SERVICE LETTER

879

Piper Aircraft Corporation

Subject: Razor Inverter Replacement

FIGURE 1

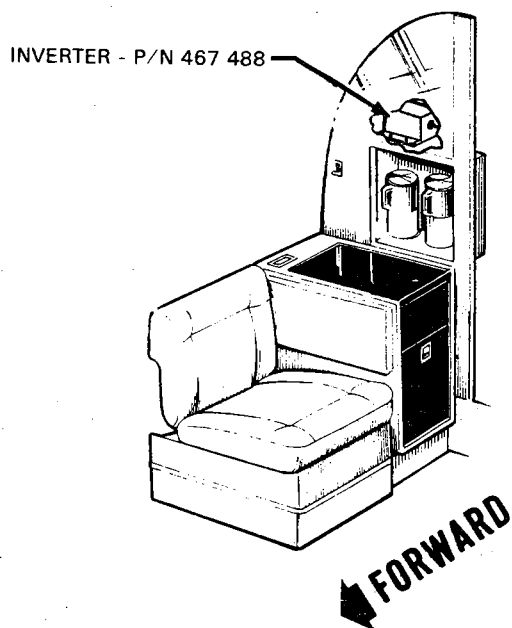
In aircraft with an aft cabinet razor inverter, there is a possibility of ADF interference which can result in ADF needle oscillation with the razor outlet switch turned "ON".

This Service Release provides instructions for replacement of the existing razor inverter with a new inverter incorporating an RF filter.

1. Gain access to Razor Inverter (Refer to attached sketch).
2. Remove existing Inverter (Piper Part Number 467 145).
3. Install new Inverter (Piper Part Number 467 488).
4. Inspect and insure cabinetry is secure.
5. Make appropriate logbook entry of compliance with this Service Release.
